Re: Turkey Point Units 3 and 4
Docket Nos. 50-250 and 50-251
Response To Request For Additional Information (RAI) 6, 10, and 11 Regarding
Supplemental Response to NRC Request for Information Pursuant to 10 CFR 50.54(f)
Regarding the Flooding Aspects of Recommendation 2.1 of the Near-Term Task Force
Review of Insights from the Fukushima Dai-ichi Accident

Turkey Point Units 3 and 4

NRC Request for Additional Information (RAI)

Regarding the Flood Hazard Reevaluation Report (FHRR)

Figure 6-1 – Points of Interest Overlaid with Site Drawing

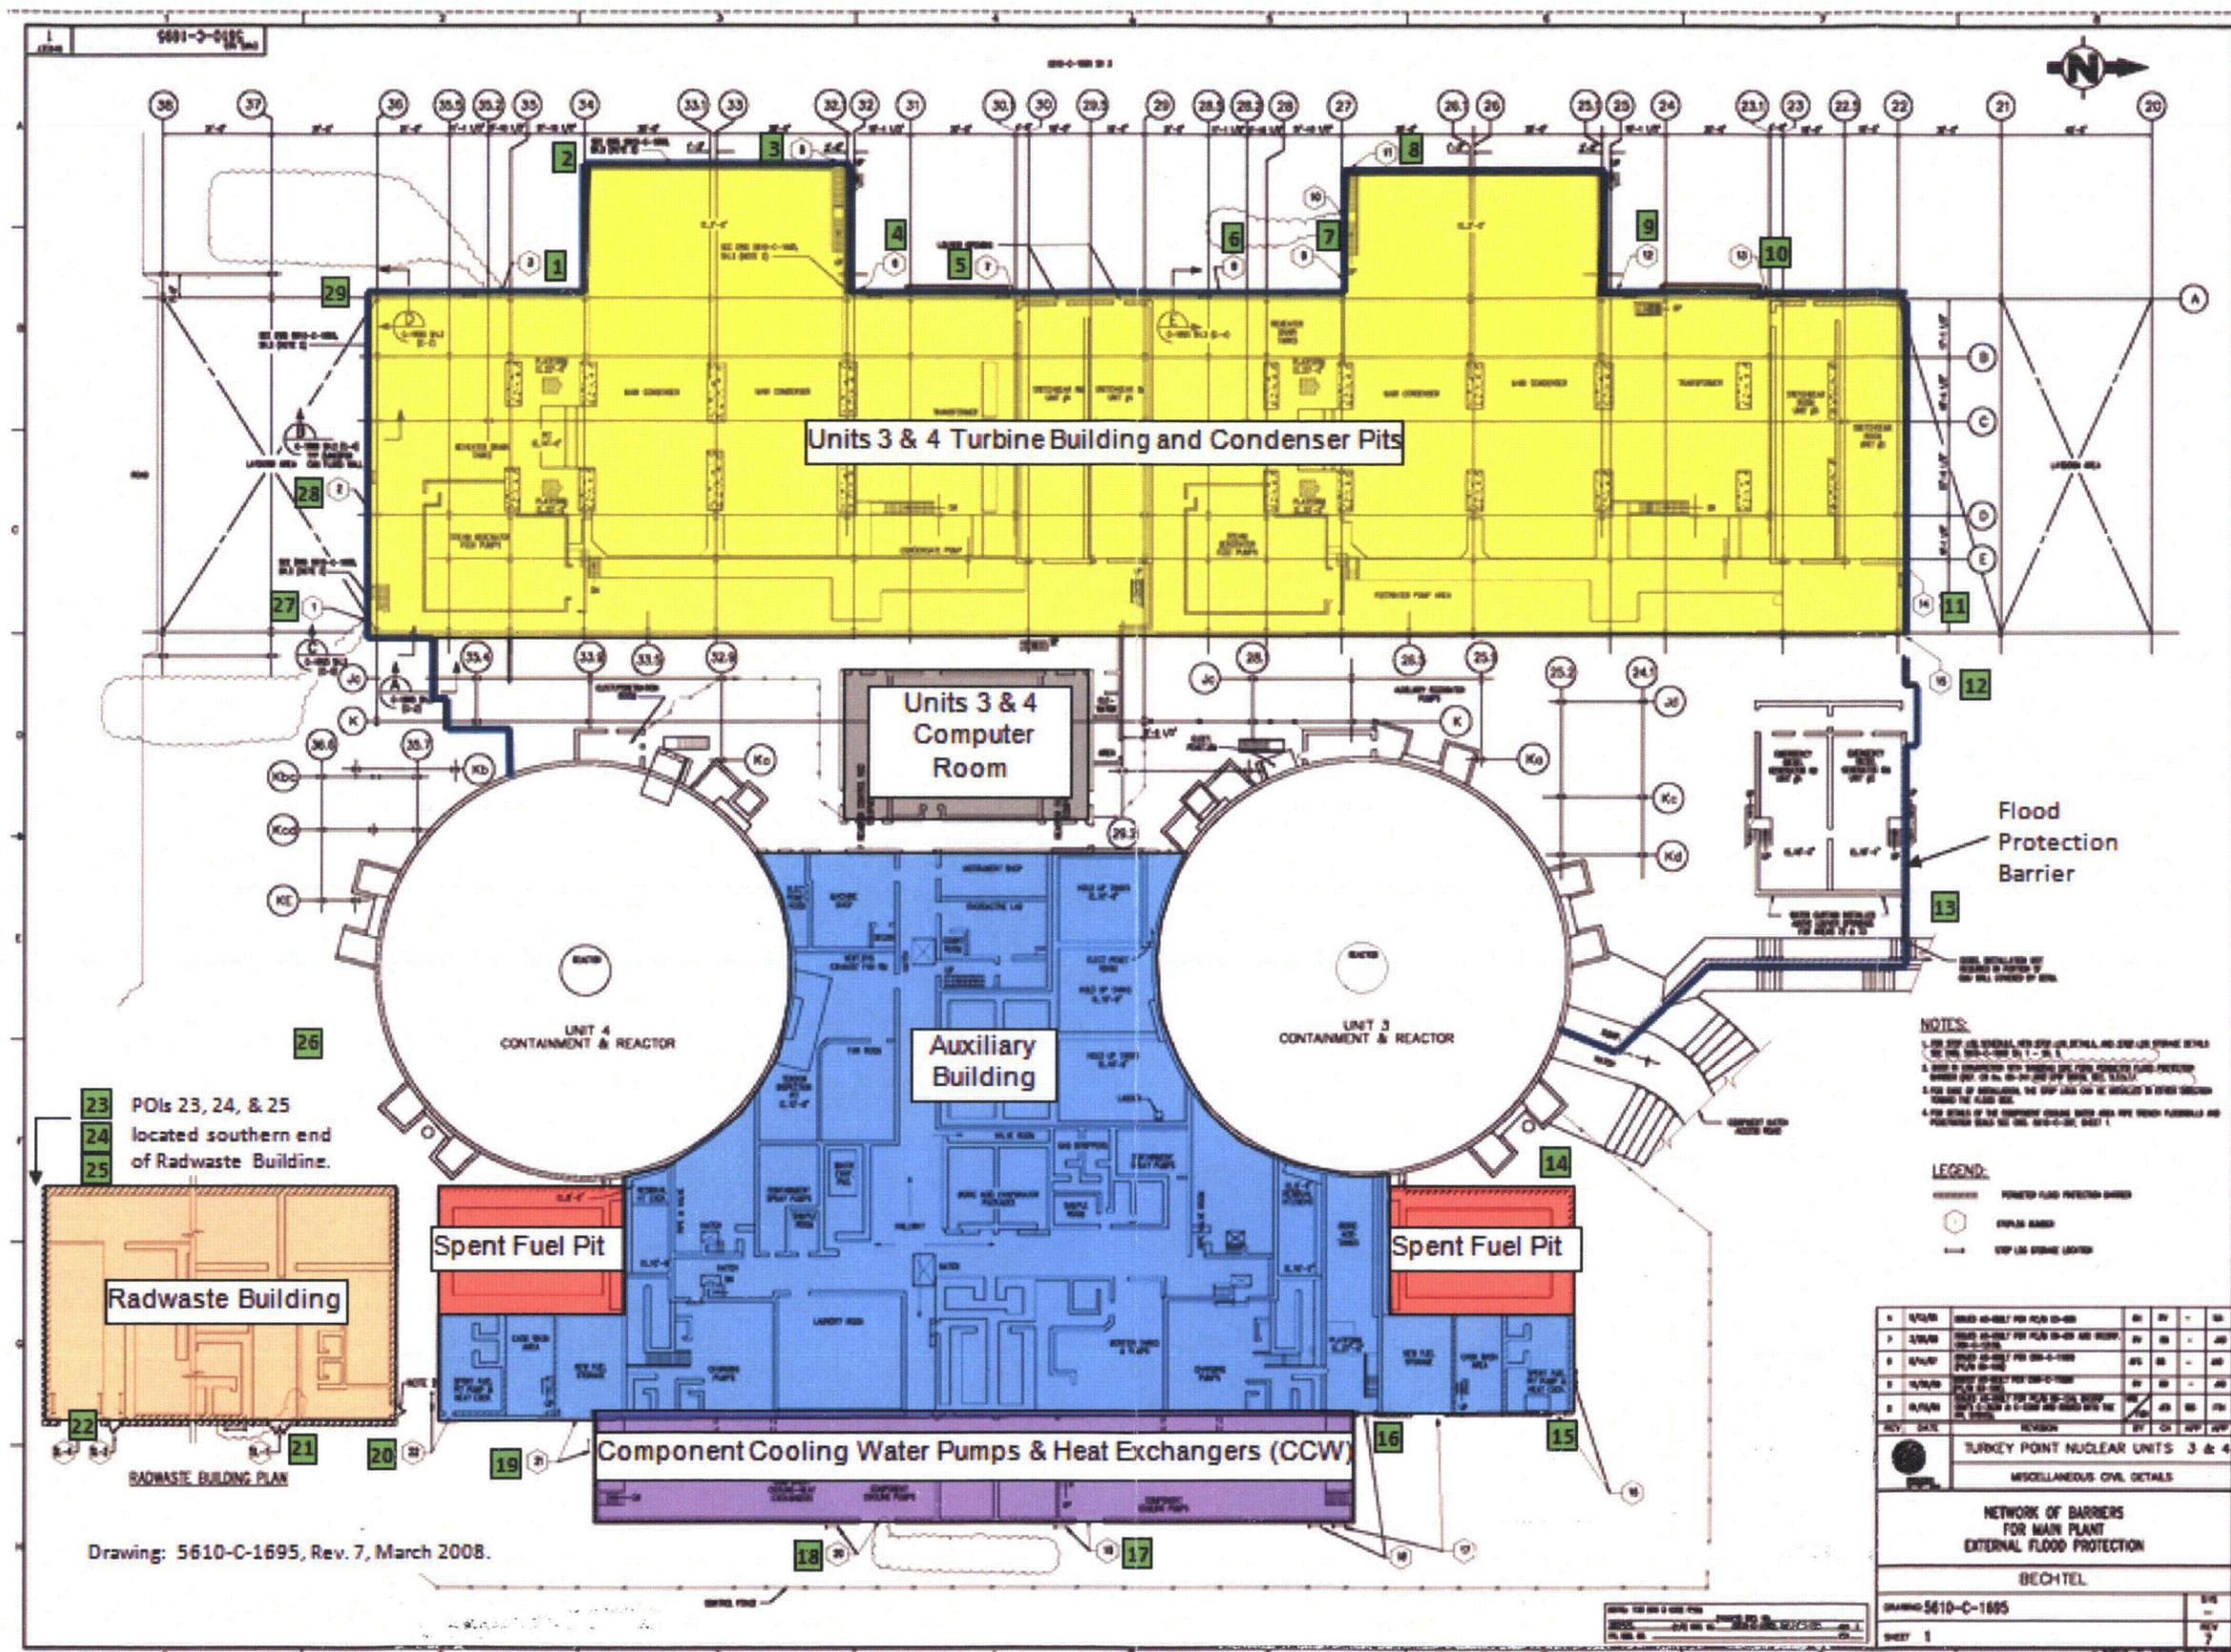
The NRC staff requests additional information to complete its review of the tabulated maximum predicted water elevations, depths, and flow velocities at 33 discrete points of interest, which the licensee identifies as potentially vulnerable areas. The NRC staff requests the licensee to provide a diagram or site plan that identifies/labels the facilities or buildings associated with the 33 locations for which flow depths and elevations are calculated for local intense precipitation Scenario A (see Table 4-2 of the FHRR). The NRC staff also requests the licensee to provide the maximum elevations and heights above local grade at the exterior of safety-related structures associated with these 33 locations. Please also confirm that evaluation of the resulting effects of water that has entered these structures will be evaluated and submitted as part of the integrated assessment.

The 33 discrete points of interest (POI) that were selected are related to potentially vulnerable areas such as openings in the perimeter flood barriers water could build up and backflow into buildings. As requested, Figures 6.1 and 6.2 identify the facilities or buildings associated with the 33 POI locations. Figure 6.1 shows facilities or buildings associated with POIs 1 through 29 and Figure 6.2 shows facilities or buildings associated with POIs 30 through 33.

Information associated with each POI location is provided in Table 6-1, including the POI location, door entry number, door entry elevation, maximum water surface elevation (WSEL), depth above the door, ground surface elevation, and depth above ground surface (flow depth). The values provided in Table 6-1 have been updated based on the response to RAI 1. The plant floor is at Elevation +15.7 feet-NAVD88 in the power block area, which includes the Turbine Building, Auxiliary Building, and Control Building.

Figure 10.1 – Illustration of Flood Event Duration (Figure 6 from NRC, 2012)

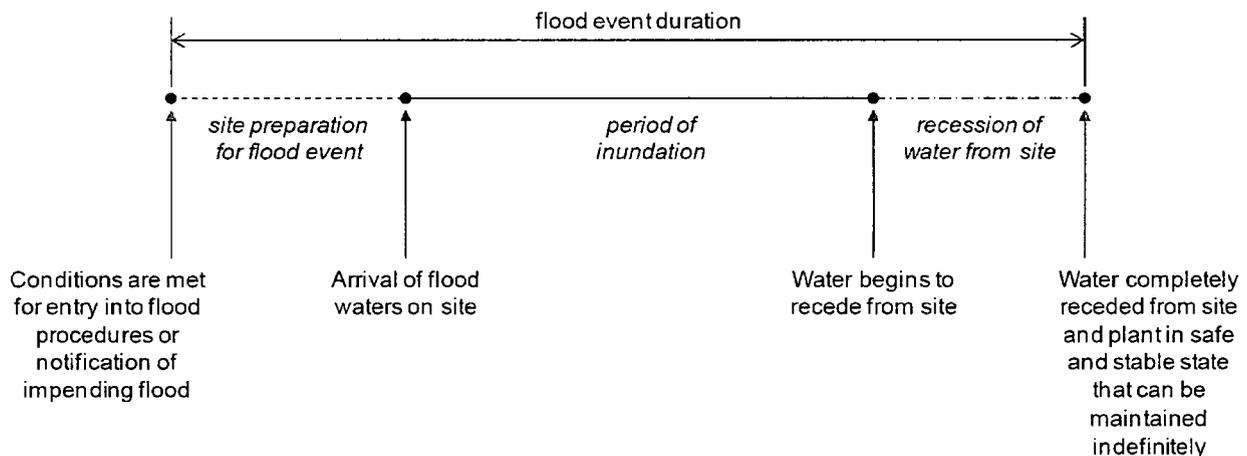
The March 12, 2012, 50.54(f) letter, Enclosure 2, requests the licensee to perform an integrated assessment of the plant's response to the reevaluated hazard if the reevaluated flood hazard is not bounded by the current design basis. The NRC staff requests the licensee to provide the applicable flood event duration parameters (see definition and Figure 6 of the Guidance for Performing an Integrated Assessment, JLD-ISG-2012-05) associated with mechanisms that trigger an Integrated Assessment. This includes (as applicable) the warning time the site will have to prepare for the event, the period of time the site is inundated, and the period of time necessary for water to recede off the site for the mechanisms that are not bounded by the current design basis. The NRC staff also requests the licensee to provide a basis for the flood event duration parameters. The basis for warning time may include information from relevant forecasting methods (e.g., products from local, regional, or national weather forecasting centers).

The Guidance for Performing an Integrated Assessment for External Flooding, JLD-ISG-2012-05 (NRC, 2012), defines the flood event duration parameters, shown in Figure 10.1:

The flood event duration is defined as the time from when conditions are met for entry into flood procedures or notification of impending flood to when water has completely receded from the site with the plant in an indefinite safe and stable state. The flood event duration can be divided into shorter durations of interest: 1) site preparation, 2) period of inundation and 3) recession from site. Site preparation may include warning time from when a meteorological forecast predicts inclement weather, as in the case of precipitation and hurricane events. Site preparation may be limited to when the flooding mechanism is initiated, such as a tsunamigenic earthquake or landslide. The period of inundation exists from when the flood arrives on site to the peak of the flooding event. The recession of water occurs between the peak of the flooding event and when flood waters have completely evacuated the site.

Figure 11.1 – PMSS Peak Flow Potential Erosion and Deposition Zones

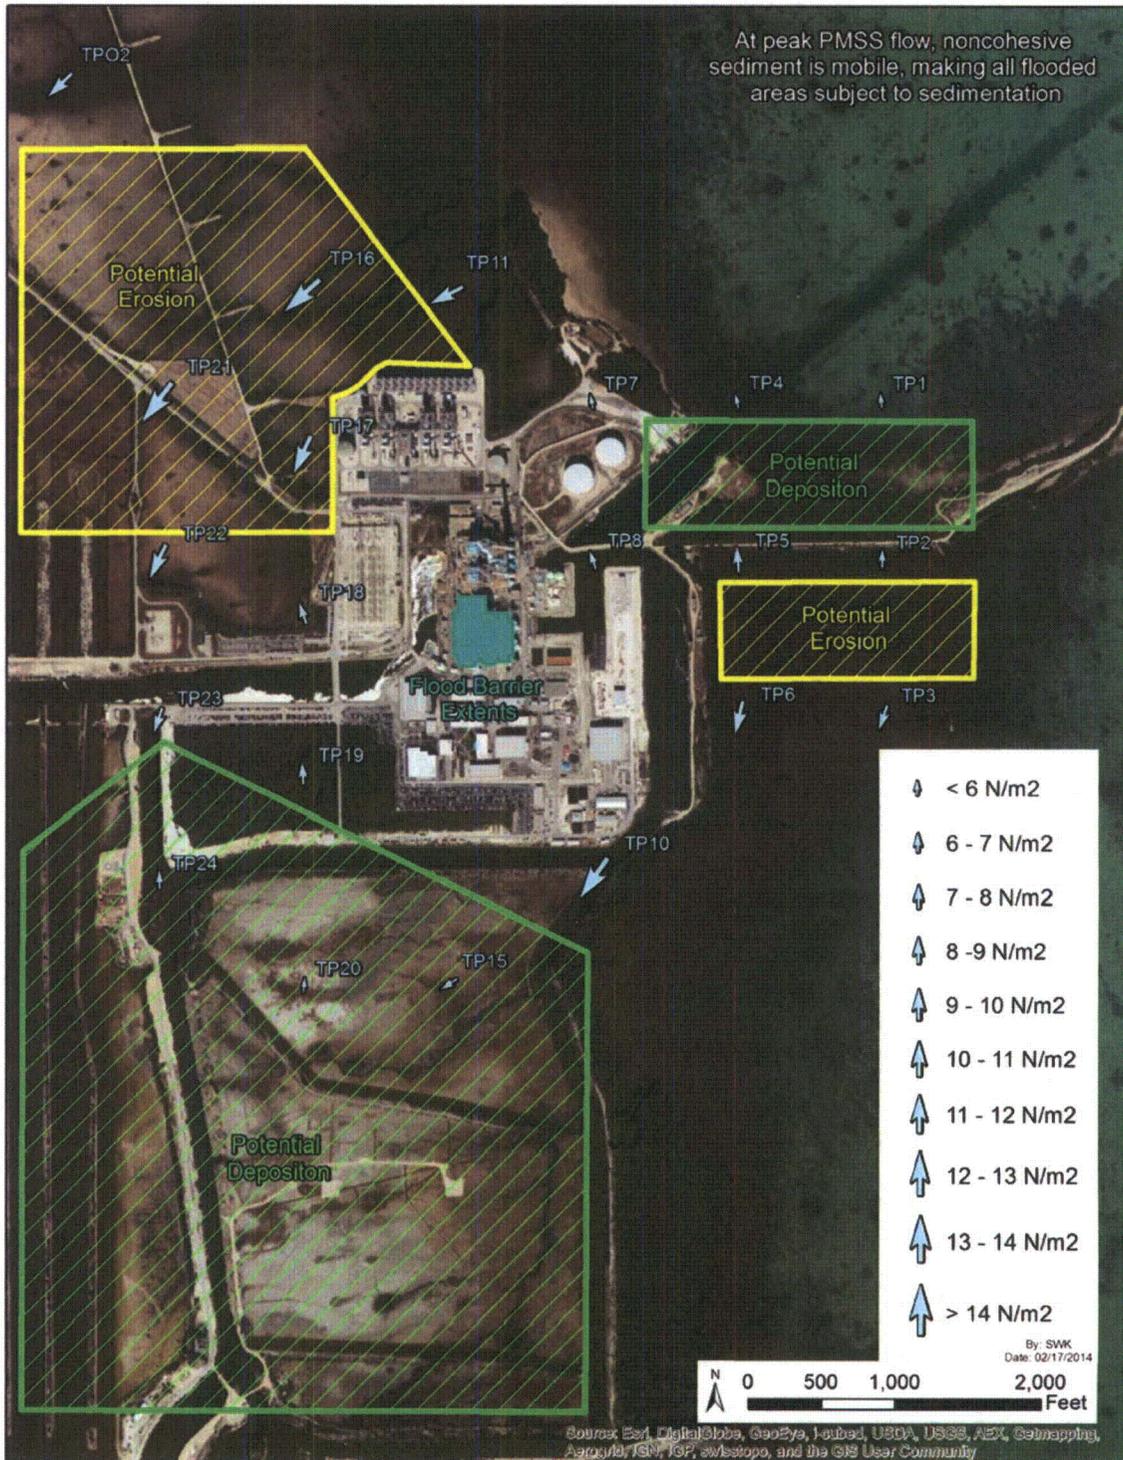
The March 12, 2012, 50.54(f) letter, Enclosure 2, requests the licensee to perform an integrated assessment of the plant's response to the reevaluated hazard if the reevaluated flood hazard is not bounded by the current design basis. The NRC staff requests the licensee to provide the flood height and associated effects (as defined in Section 9 of JLD-ISG-2012-05) that are not described in the flood hazard reevaluation report for mechanisms that trigger an Integrated Assessment. This includes the following quantified information for each mechanism (as applicable):

- *Hydrodynamic loading, including debris,*
- *Effects caused by sediment deposition and erosion (e.g., flow velocities, scour),*
- *Concurrent site conditions, including adverse weather,*
- *Groundwater ingress, and*
- *Other pertinent factors (e.g., waterborne projectiles).*

Note that PTN currently has a sedimentation monitoring and maintenance plan for the cooling water and intake canal systems; thus, the canal systems are well maintained. For the sedimentation study, flow velocities and bed shear stresses were evaluated to determine areas vulnerable to accumulated erosion and deposition during the PMSS. The peak bed shear stresses during the PMSS (Figure 11.1) are capable of mobilizing noncohesive sediment typical near PTN. Potential erosional and depositional areas were determined from comparison of the relative magnitudes and directions of sediment transport (Figure 11.1). In general, the peak bed shear stresses move in a northeast-to-southwest direction, indicating erosion from Biscayne Bay east of the plant and eventual deposition to the west of PTN. However, localized effects can drive sediment in other directions and produce smaller zones of erosion and deposition, such as those east of PTN (Figure 11.1). Maximum erosive scour depth of up to 2 feet is possible along vertical structures (e.g., observation points TP5, TP6, and TP8 on Figure 11.1) at plant grade. Further, during the PMSS recession, deposition is possible over the inundated area (Figure 11.2). The depth of potential sediment accumulation is bounded by the peak local water depth during the PMSS. It is noted that operational challenges due to sedimentation have not been experienced at PTN in past hurricanes including Hurricane Andrew.
